44th Ave Manatee County  
County Project No. 6086960

No.	REVISIONS	DATE	BY	AS NOTED	TIMOTHY M. CURRAN, P.E. P.E. NO. 34809 AECOM TECHNICAL SERVICES, INC. 7650 WEST COURTNEY CAMPBELL CAUSEWAY TAMPA, FL 33607-1462 (813) 286-1711 CERTIFICATE OF AUTHORIZATION: 8115	DATE		DESIGN ENGINEER	<b>GRINDER LIFT STATION AT ELWOOD 1 PS NOTES</b>	SHEET NO.
				DESIGNED BY		R.A.		FEBRUARY 2019		TIMOTHY M. CURRAN, P.E.
				DRAWN BY	T.S.	PROJECT NO.		FL. LICENSE NO.		
				CHECKED BY	T.C.	6086960		34809

AS NOTED DESIGNED BY: C.T. DRAWN BY: T.S. CHECKED BY: C.T.				CARLOS TURCIOS, P.E. P.E. NO. 64578 AECOM TECHNICAL SERVICES, INC. 7650 WEST COURTNEY CAMPBELL CAUSEWAY TAMPA, FL 33607-1462 (813) 286-1711 CERTIFICATE OF AUTHORIZATION: 8115		DATE: FEBRUARY 2018 PROJECT NO.: 6086960		 PUBLIC WORKS DEPARTMENT ENGINEERING SERVICES 1112 24th Avenue East, Bradenton, FL 34208 Sonnenberg, Terence		DESIGN ENGINEER: CARLOS TURCIOS, P.E. FL. LICENSE NO.: 64578		<b>GRINDER LIFT STATION AT ELWOOD 1 PS ELECTRICAL SITE PLAN</b>		SHEET NO.: ULS-6
ADDENDUM REVISIONS		DATE: 12/19/19	BY: TS

**GRINDER LIFT STATION  
AT ELWOOD 1 PS  
ELECTRICAL DETAILS**

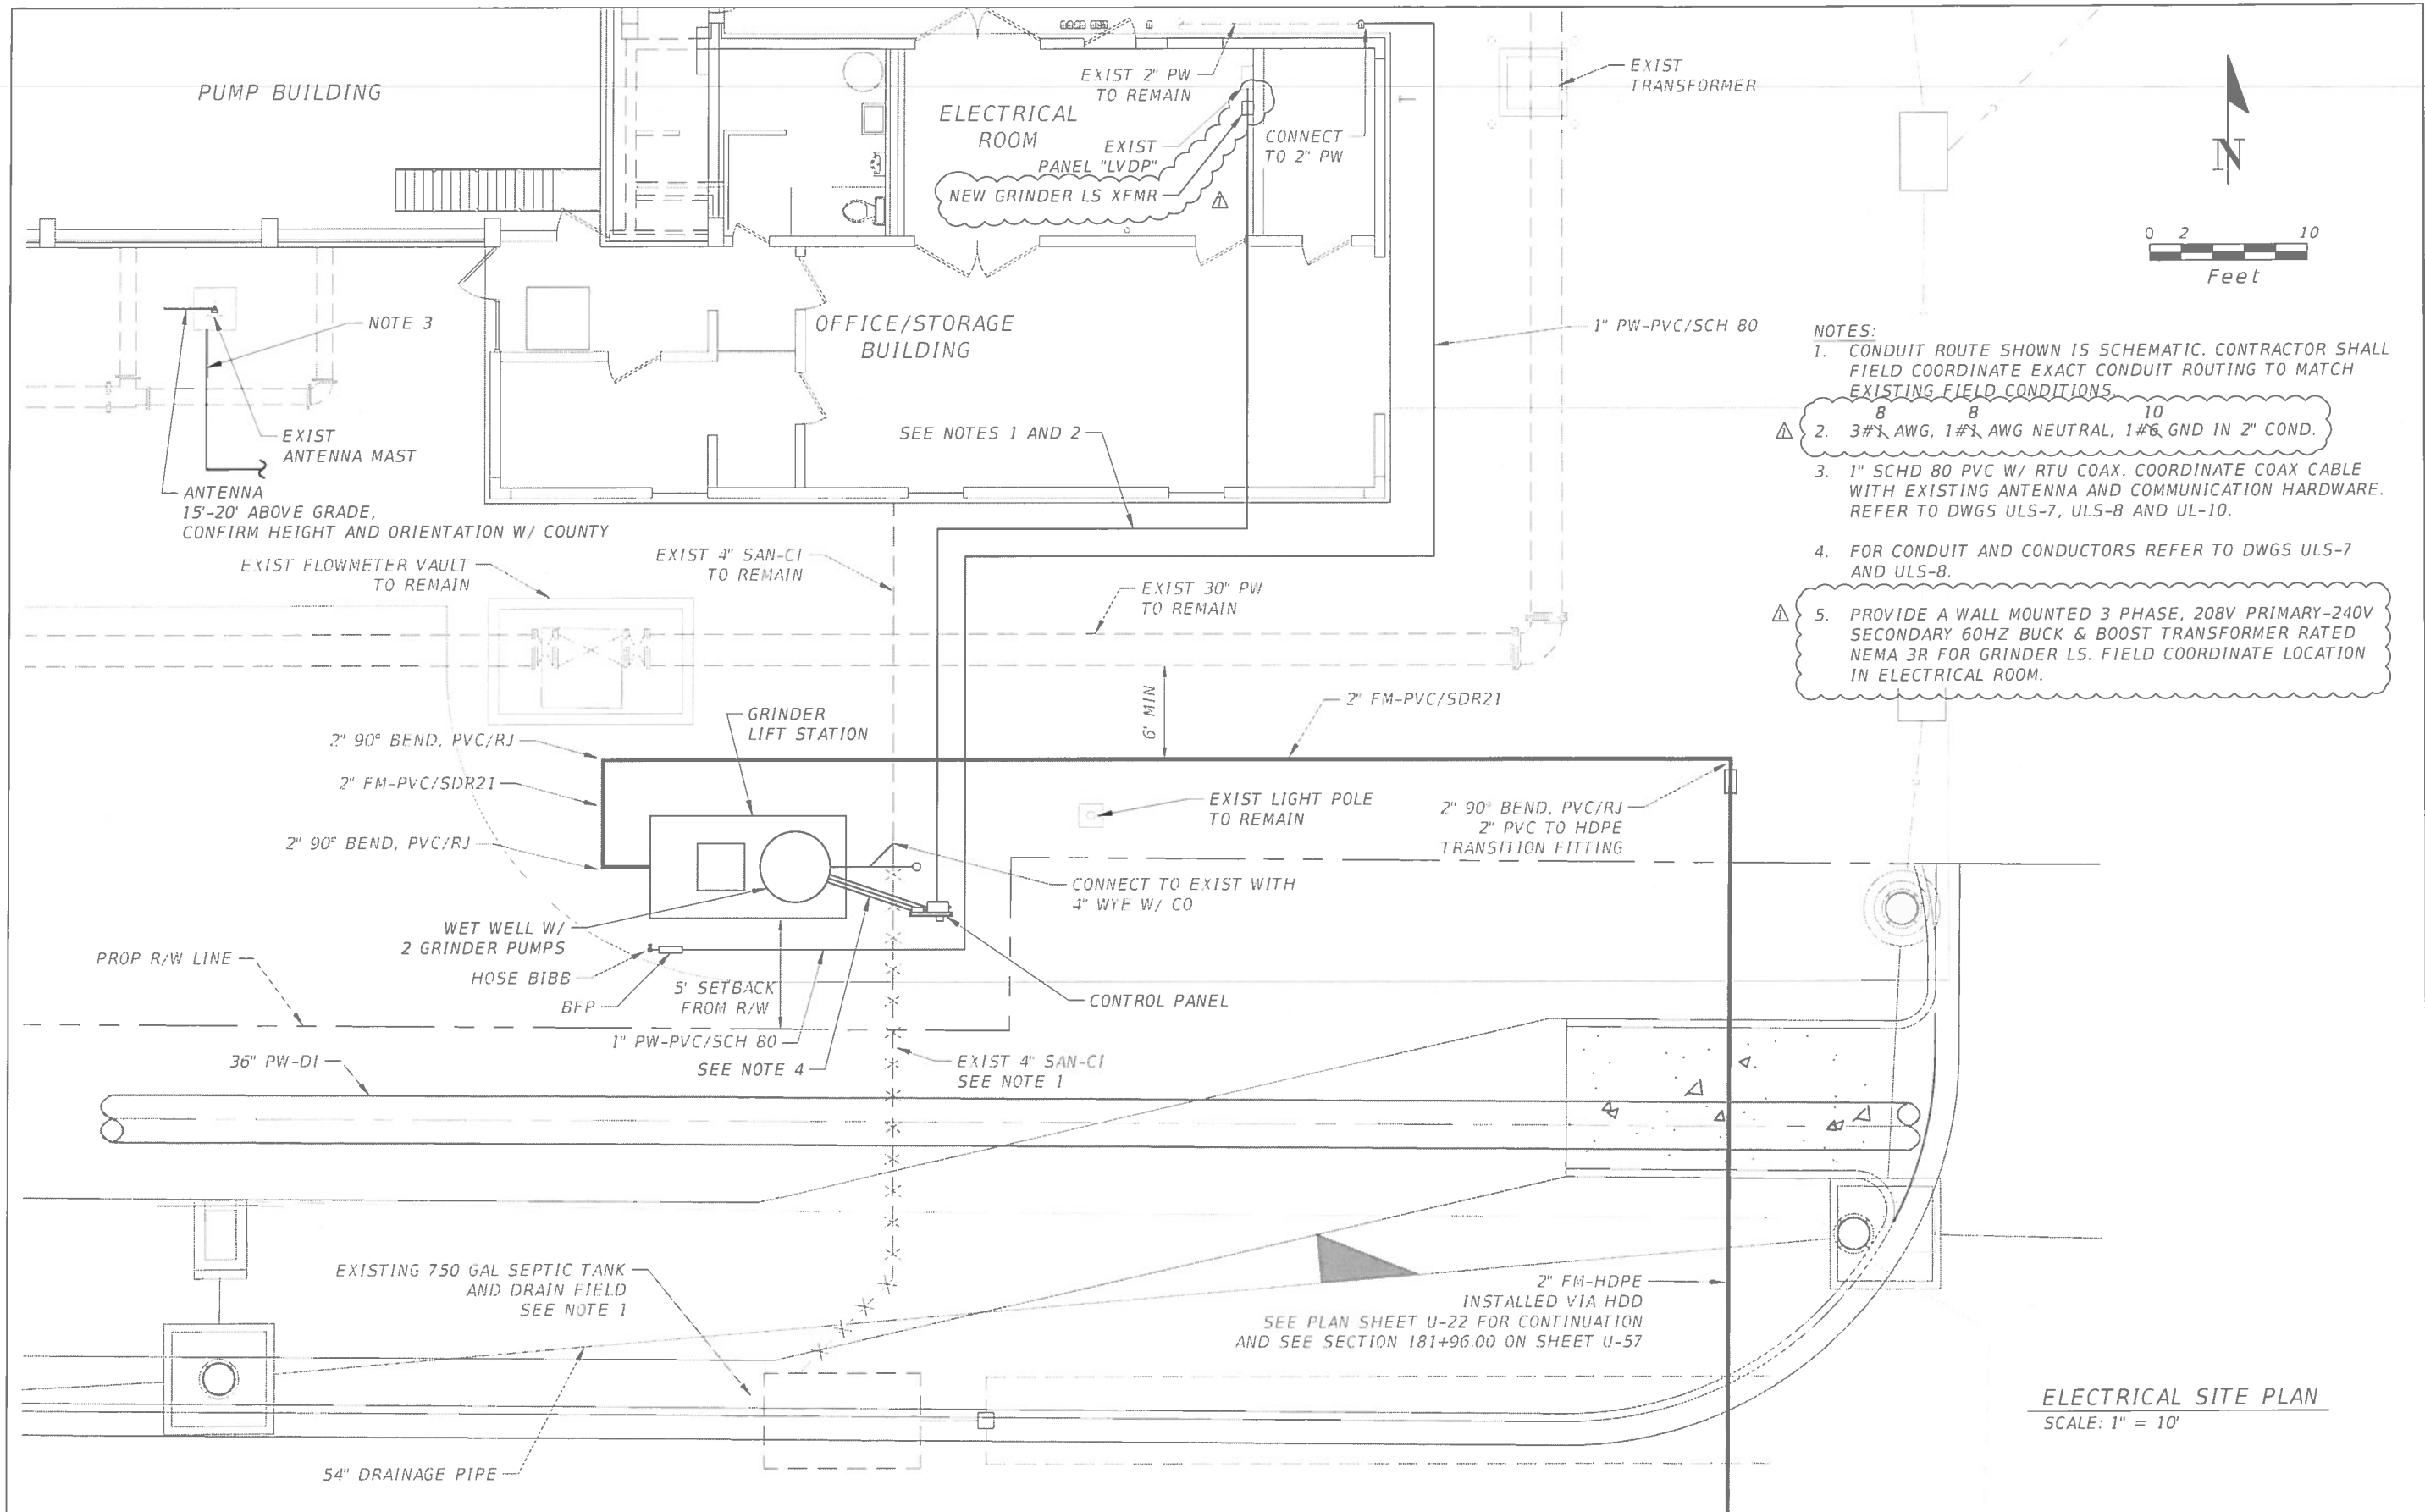
MANUFACTURER	HYDROMATIC	2	HP
MODEL	HPG200	20	FT/TDH
GPM	41	3	PHASE
VOLTAGE	<del>208</del> 230 $\Delta$	4	IMPELLER (INCHES)
DISCHARGE (INCHES)	1.25
